Houston Lighting & Power

ST-HL-AE-3636

South Texas Project Electric Generating Station  
Units 1 & 2  
Docket Nos. STN 50-498, STN 50-499  
Responses to NRC Request for Additional Information on  
Fire Risk Analysis in the Probabilistic Safety Assessment (PSA)  
South Texas Project Electric Generating Station (STPEGS)

ATTACHMENT 1  
RESPONSES TO NRC QUESTIONS ON THE STP  
PSA FIRE RISK ANALYSIS

Figure 1-1. Comparison of Panel Fire Severity Factors from Original STP PSA Analysis and Rancho Seco Fire Sensitivity Study

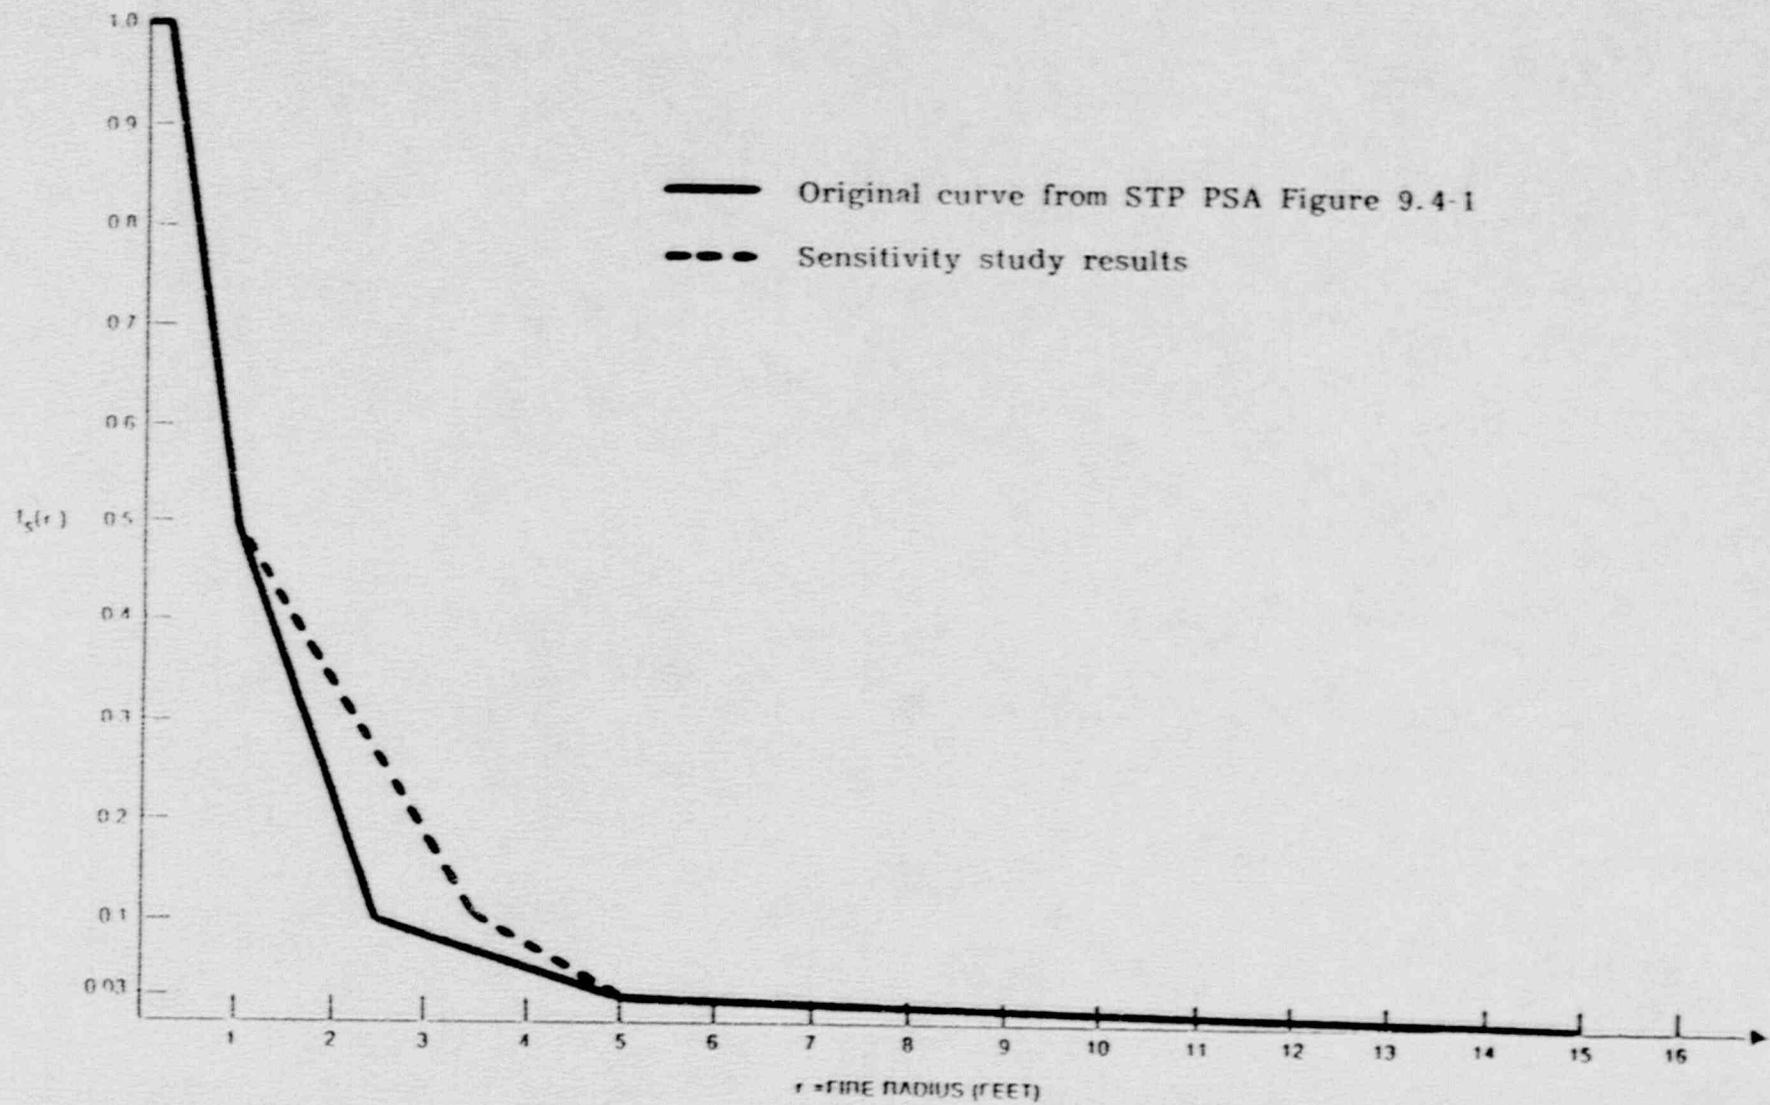
1. The licensee is requested to discuss the relevance of the Rancho Seco annunciator control panel fire on the STPEGS PSA. (SNL will provide information on the fire to the licensee.)

Attachment 1.1 presents a sensitivity study that was performed to investigate the impact on the severity curve presented in STP PSA Figure 9.4-1 from adding the Rancho Seco fire to the panel fire event database. Two considerations indicate that the results from this sensitivity study may be quite conservative and inappropriate for use in a realistic fire analysis.

Response: The referenced fire at Rancho Seco occurred in an annunciator control panel located in an auxiliary equipment room outside the main control room. This fire and two possibly related fires at Calvert Cliffs Unit 2 and Beaver Valley Unit 2 seem to have been caused by overheating of carbon resistors or other components on annunciator input circuit cards and were compounded by excessively high trip current ratings for the circuit breakers that protect these cards. The Calvert Cliffs and Beaver Valley fires also occurred in panels outside the main control room, and they were much smaller than the Rancho Seco fire. All three fires occurred in panels manufactured by Electro Devices, Inc. The South Texas plant does not contain any panels from this manufacturer.

Figure 1-1 duplicates the panel fire severity curve from Figure 9.4-1 in the STP PSA final report and shows the results from the sensitivity study presented in Attachment 1.1. As noted in the study, the overall impact from including the Rancho Seco fire is quite small, increasing the combined geometry and severity factor for control room fire Scenario 6 by approximately 5%. When considered in the context of the database biases introduced by including only the Rancho Seco fire, this conclusion confirms that the original severity curve in Figure 9.4-1 quite reasonably represents the available data and may, in fact, be somewhat conservative.
